## 5-Agency Technical Recommendations for the Location of BDCP Intakes 1-7

December 13, 2011

**Figure 1.** Potential North Delta Diversion Locations Reviewed by the FFTT [Extracted from the 2011 FFTT Technical Memorandum]. Note that the symbols reflect the center-point of the potential screens.

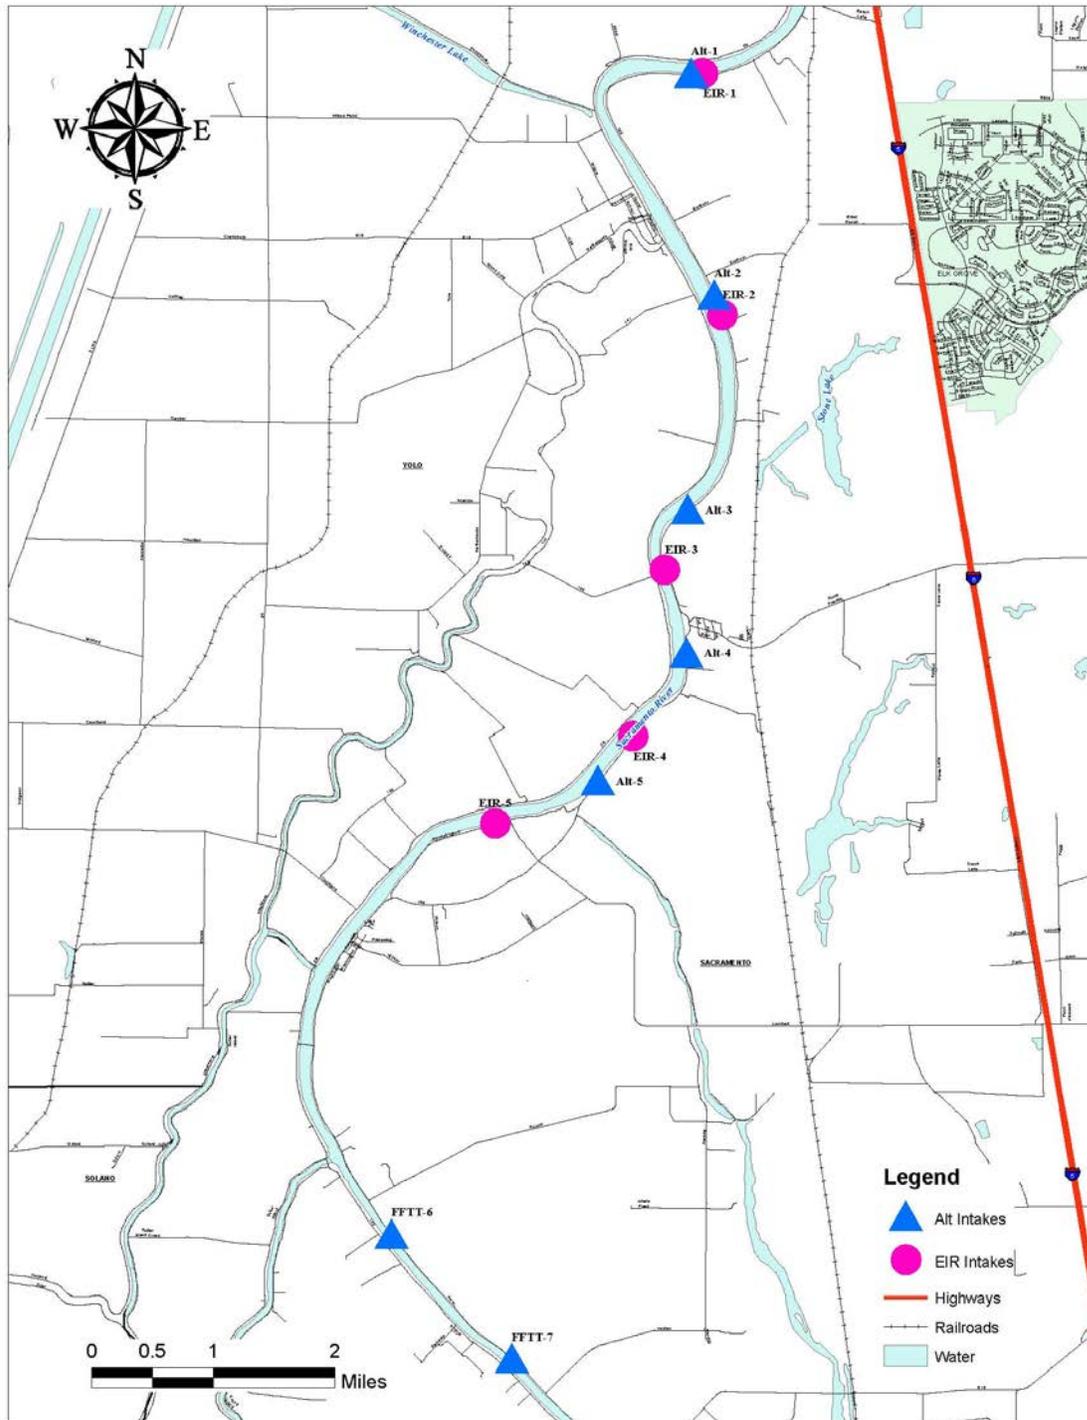
*Intake 6 & 7* – The 5-Agencies recommend continuing to use the locations for sites 6 & 7 developed during the FFTT process (see Fig 1).

Figure 2. Alt 1 and CER 1. Note, recommendation circled in red.

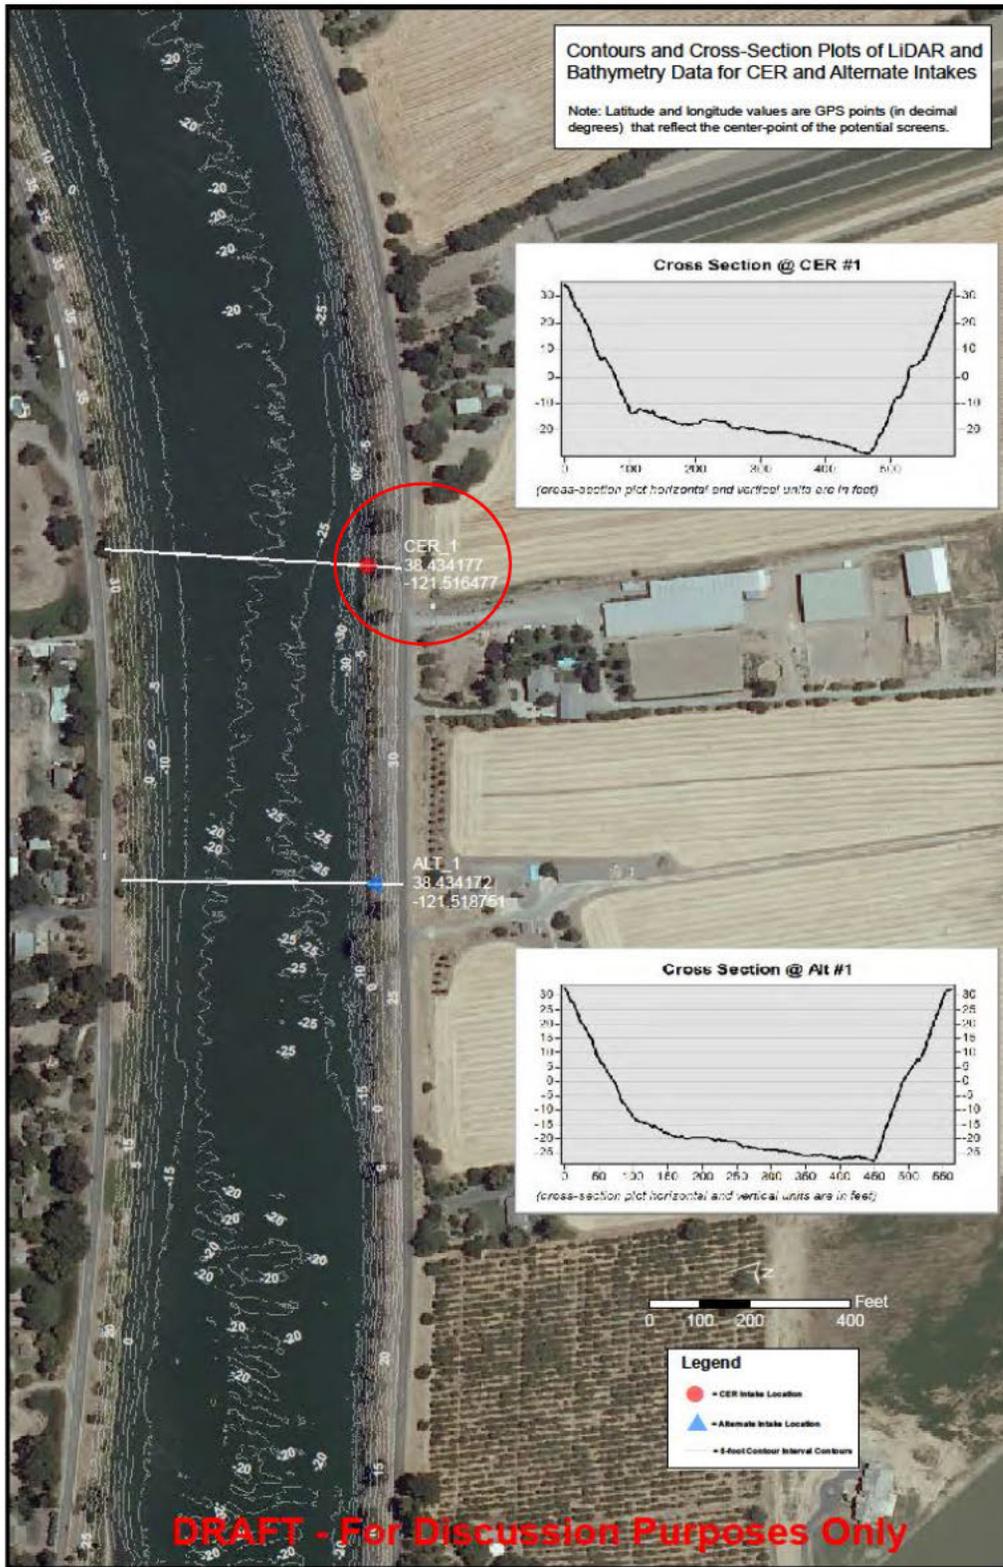
*Intake 1* – The 5-Agencies recommend the use of CER 1 (or EIR 1) (See Fig 2).

Rationale - The center-point of the potential screens for Alt 1 and CER 1 are approximately 650 ft apart. The designed screen height of either diversion would be approximately 19 feet (Table 1). The differences between the two locations were not significant enough to warrant altering the footprints already developed by DWR during the CER process. The preliminary footprints for sites Alt 1 and CER 1 overlapped significantly.

Figure 3. Alt 2 and CER 2. Note, recommendation circled in red.

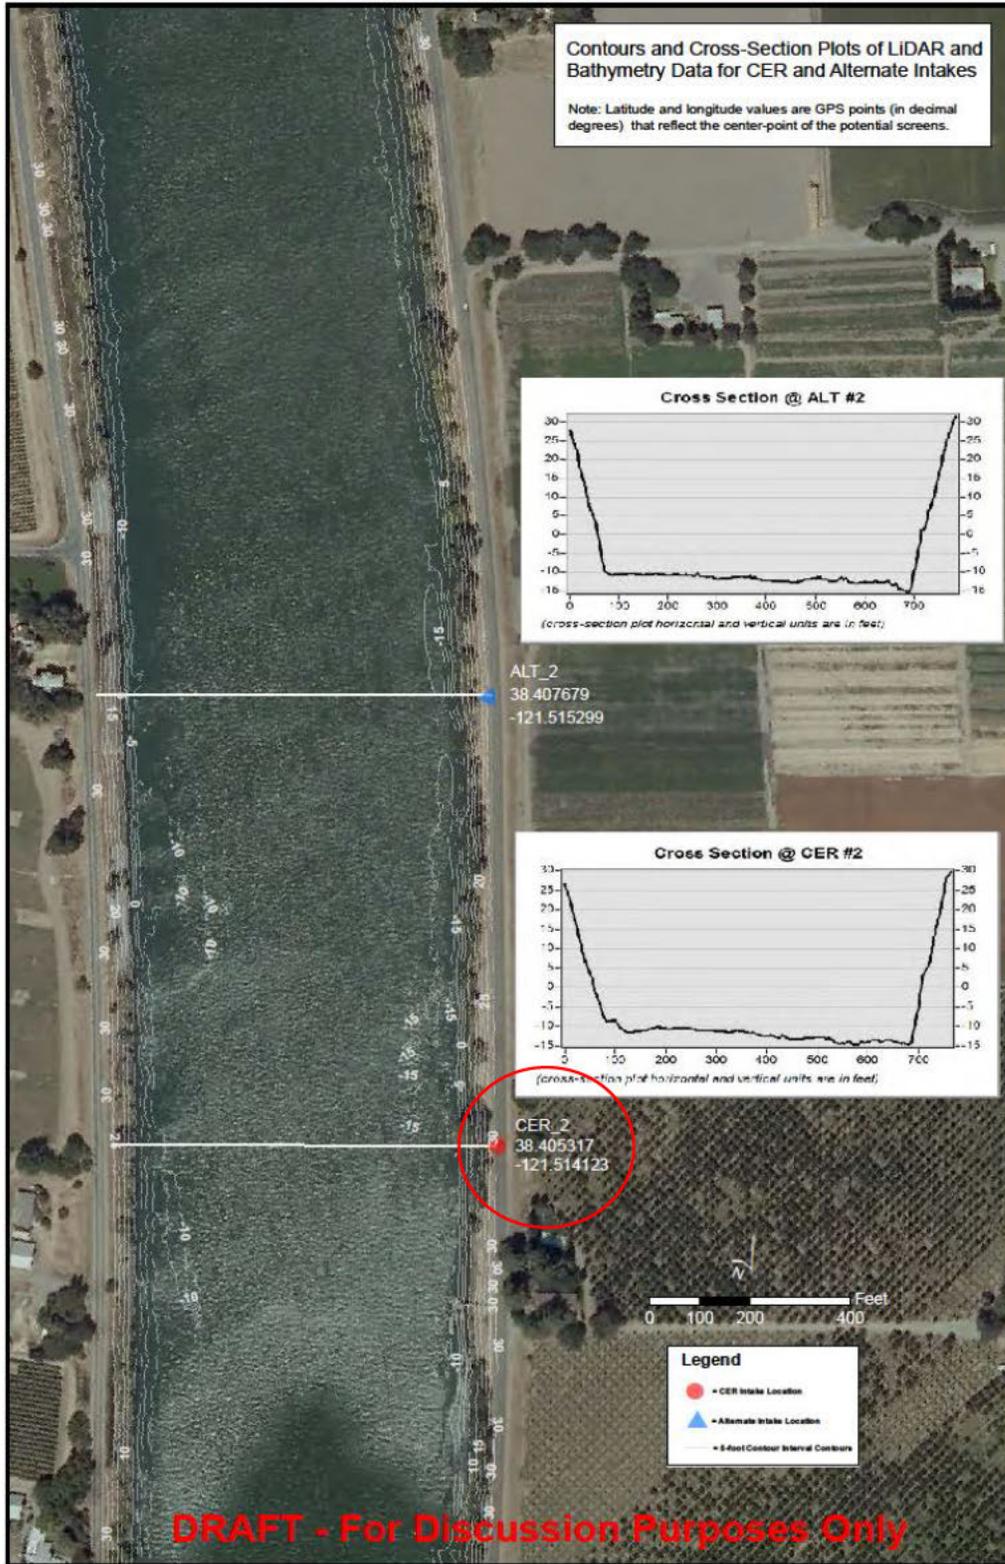
*Intake 2* – The 5-Agencies recommend the use of CER 2 (or EIR 2) (See Fig 3).

Rationale – Similarly to intake 1, the center-point of the potential screens for Alt 2 and CER 2 are close in proximity with overlapping footprints. The differences between the two locations were not significant enough to warrant altering the footprints already developed by DWR during the CER process. The designed screen height of either diversion would be approximately 11 ft (Table 1). Alternative locations for intake 2 are shallower than the other seven locations; thus intake 2 could require the longest screen length. Alternatives solutions to reducing screen length will be pursued.

Figure 4. Alt 3 and CER 3. Note, recommendation circled in red.

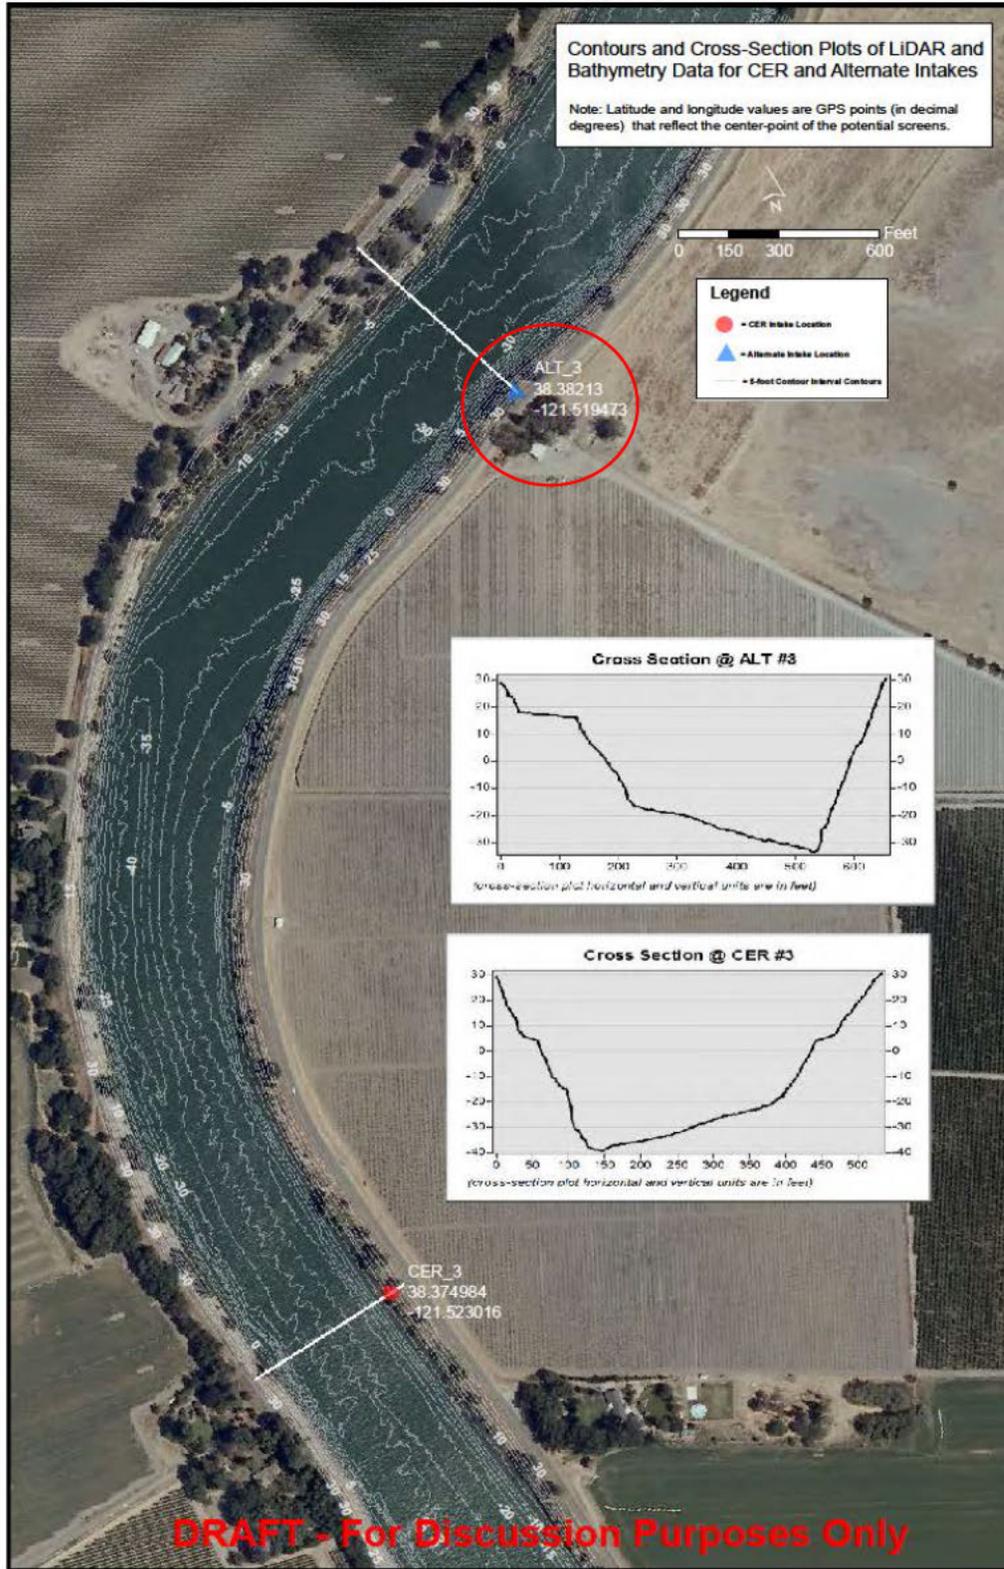
*Intake 3* – The 5-Agencies recommend the use of Alt 3 (see Fig 4).

Rationale – Alt 3 is located on the outer bend at the downstream end of a curve. Whereas, CER 3 is positioned on the inner bend of a relatively sharp river bend, with shallower bed elevations (Table 1). Design screen height for Alt 3 would be approximately 22 ft and 10 ft for CER 3 (Table 1). For both Alt 3

and CER 3, the inside of the levee is rip-rapped with sparse vegetation. During the field visit, CER 3 showed undesirable signs of shallow depths (exposed sandy edges near the water line) due to the location of the site relative to the river bend. The FFTT in their 2011 report rated CER 3 as poor due to the location on the bend. Deeper sites are more appropriate to avoid the potential sediment build-up over time that can occur in-front of the screens. Alt 3 was rated higher by the FFTT due to location on the river and adequate average bed elevations for screen placement. CER 3's proximity to the town of Hood (where Hood Franklin Road dead ends into 160) increases its potential for land use/community impacts. With respect to terrestrial biological resources, the two locations were similar. With respect to agricultural land use, CER 3 supports row crops and includes prime farmland under Williamson Act contract; Alt 3 supports pear orchards, alfalfa, wheat row crops, and grazing land on non-Williamson Act land.

Figure 5. Alt 4 and CER 4. Note, recommendation to locate screen between Alt 4 and CER 4 coordinates as marked in red.

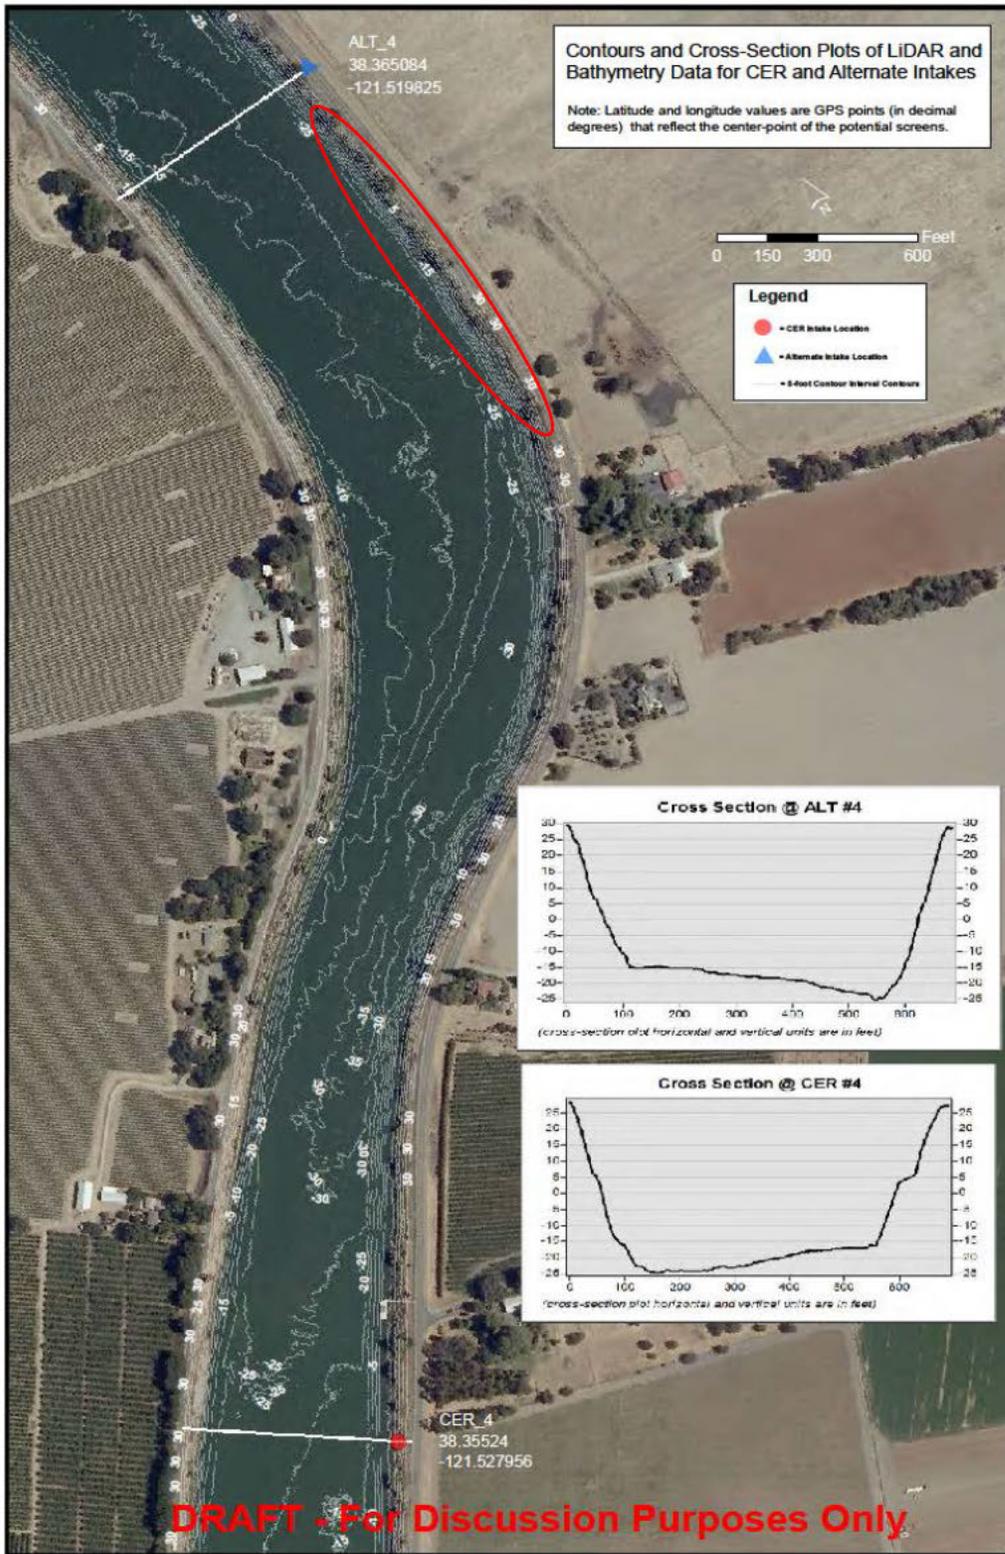
*Intake 4* – The 5-Agencies recommend locating intake 4 in between Alt 4 and CER 4 (see Fig 5).

Rationale – CER 4 was rated as poor by the FFTT due to its location on the downstream end of a short river bend. The design screen height of Alt 4 would be approximately 16 ft and 11 ft for CER 4 (Table 1). In the field, CER 4 showed signs of shallow depths (exposed sandy edges), which validated the FFTT's identification of this site being a poor location for a diversion. Alt 4 met the depth requirements of the criteria, but had substantial land-side impacts from the temporary and permanent footprint to the town of Hood. Community/land use impacts were identified as a potential concern with the Alt 4 location. With respect to terrestrial biological resources, the river-side of the levee at CER 4 supported a cluster of large trees, which could serve as habitat for special-status species. A previous survey of CER 4 documented elderberry shrubs at the southern portion of the CER 4 location. At Alt 4, riparian vegetation associated with a slough could support special-status species. With respect to agricultural land use, CER 4 supports pear orchards and row crops, while Alt 4 supports row crops and grazing land. It was noted that a natural gas field (Hood-Franklin) was in the proximity of intake 4 site locations. In order to avoid potentially substantial impacts to the town of Hood, the group reviewed the bathymetry map for a location between Alt 4 and CER 4 that had suitable depths adequate for function of the structure. Just downstream of Alt 4, and upstream of CER 4, bed elevations occur in the -20' to -30' depths. The group recommends adjusting the placement of the screen in between the coordinates of Alt 4 and CER 4, as shown in red marking on Fig. 5, minimizing direct impacts to the town of Hood and potential special-status species habitat along the slough.

Figure 6. Alt 5 and CER 5. Note, recommendation circled in red.

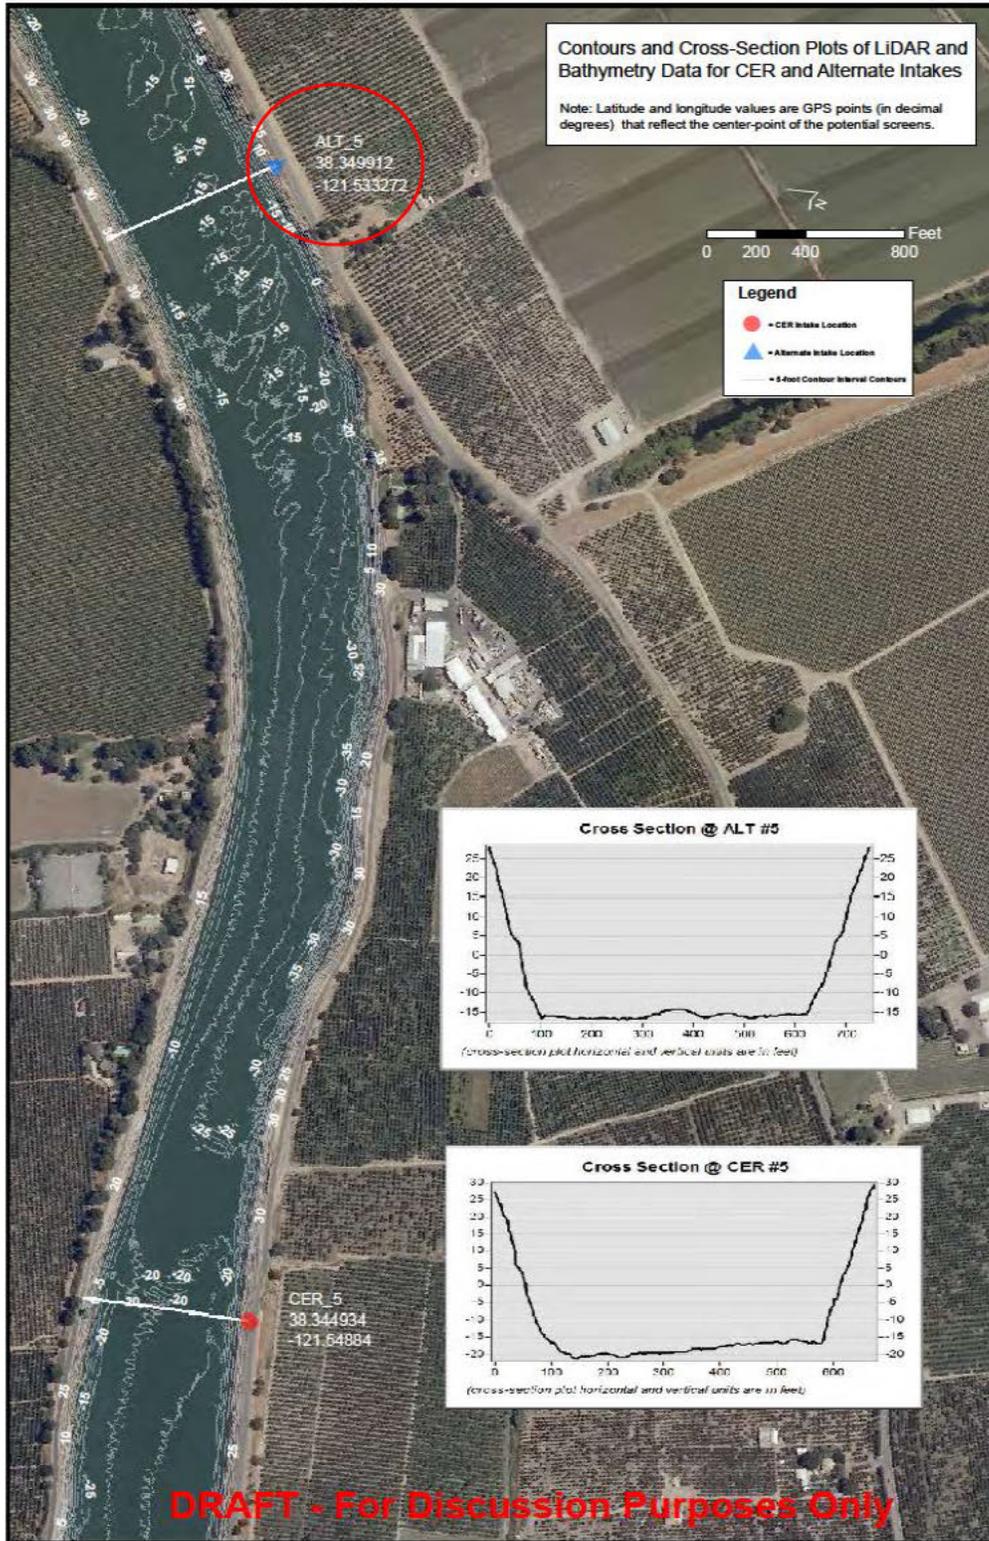
*Intake 5* – The 5-Agencies recommend the use of Alt 5 (see Fig 6).

Rationale – Alt 5 is located on an outer bend near the upstream end of a gentle river bend. The FFTT rated it good to moderate based on its position along the river bend. CER 5 is located on Randall Island, on the downstream end of a short river bend with shallow bed elevations (Table 1). This site rated poor to moderate by the FFTT due to location relative to the river bend. The design screen height for Alt 5 is approximately 15 ft and 10 ft for CER 5 (Table 1). When evaluating the land-side impacts for the two options, it was noticed that Alt 5 would require scenic-route Hwy 160 to be relocated, whereas CER 5 had no footprint impacts to Hwy 160. The footprint for Alt 5 would have impacts to the tip of Snodgrass Slough, which was identified as suitable habitat for the giant garter snake. With respect to agricultural land use, CER 5 supports row crops and includes prime farmland under Williamson Act contract; Alt 5 supports pear orchards, alfalfa, and wheat row crops on non-Williamson Act land. CER 5 is located over a natural gas field (Merritt Island). The preferable location for intake 5 would be to locate the screen along the outside curvature of the river bend in-between Alt 5 and CER 5, in order to take advantage of the suitable deeper river bottom elevations on this stretch of the river (ranging from -25' to -35' deep) to reduce the overall length of the screens. However, it was recognized that locating the diversion in-between Alt 5 and CER 5 would have a detrimental hydraulic impact on the facility. Also, moving the site into a narrower section of the river would make it more difficult to keep from encroaching into the flood freeboard, both during and after the construction of the facility. In order maintain operational function of the facility, Alt 5 location is recommended by the group. Since Alt 5 would result in a design screen height below the preferred 15 ft minimum height, it was acknowledged that other efforts to reduce the screen length would be examined. Concepts for addressing the screen length issue include but are not limited to variations to screen height, approach and sweeping velocity, diversion capacities per diversion, phasing, and examining alternative locations such as Intakes 6 & 7.
